**LOST CREEK ISR, LLC**

**Re: Response to NRC RAIs Dated July 23, 2015  
UIC Class V Amendment  
Lost Creek ISR Project License SUA-1598, Docket 040-09068**

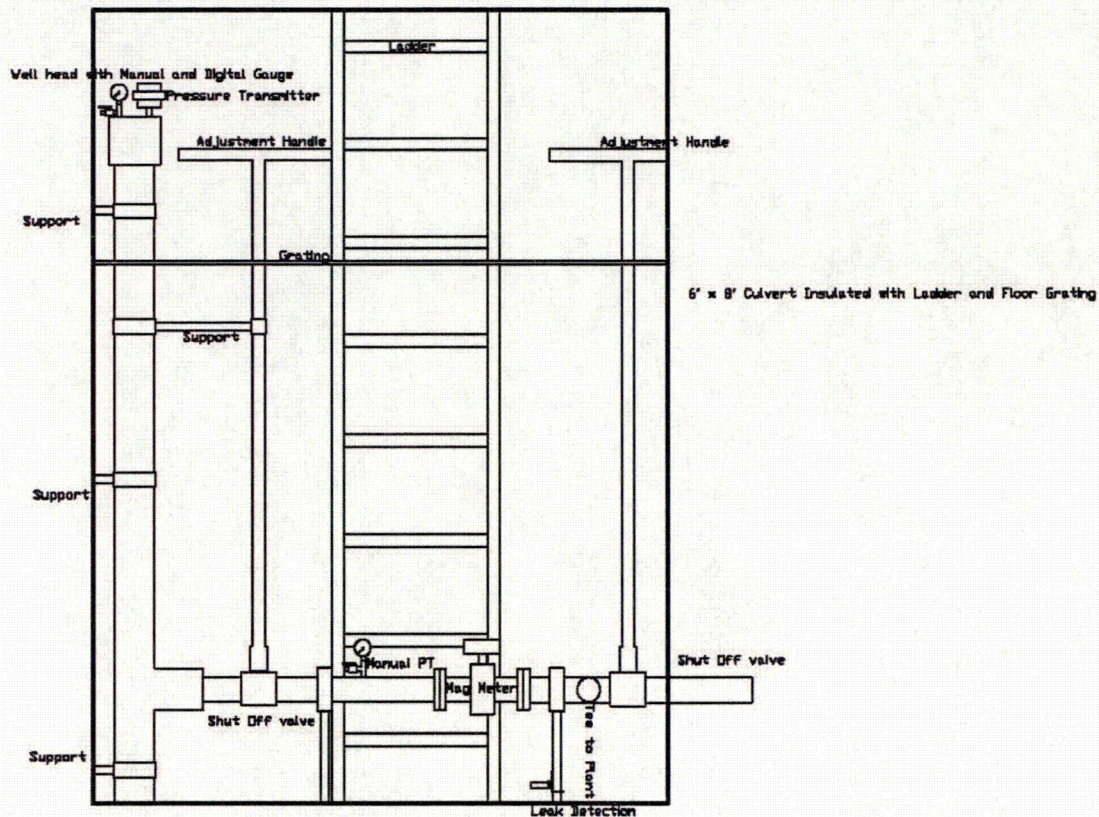
- A) Hydraulic Conductivity – Appendix B uses a value of 0.59 feet per day for the PHAST analysis but the calculations in Section 4.2 Maximum Area of Impact and Section 2.4 Receiving Aquifer Characteristics uses or suggest that the horizontal hydraulic conductivity exceeds 1 foot per day.

The June 2014 geochemical modeling of the permeate injection response was performed six months prior to conducting the first FG Horizon pump test (December, 2014). Lacking actual FG Horizon aquifer characteristic values, HJ Horizon hydraulic conductivity values were deemed representative and appropriate substitute model input parameters. The reviewer is reminded that all named horizons are derived from the same depositional environment, thus they should have similar aquifer characteristics, which the December 2014 tests confirmed. The higher hydraulic conductivity value used in the "Maximum Area of Impact" calculation is a pump test derived value, and its use results in a more conservative estimate of potential impact.
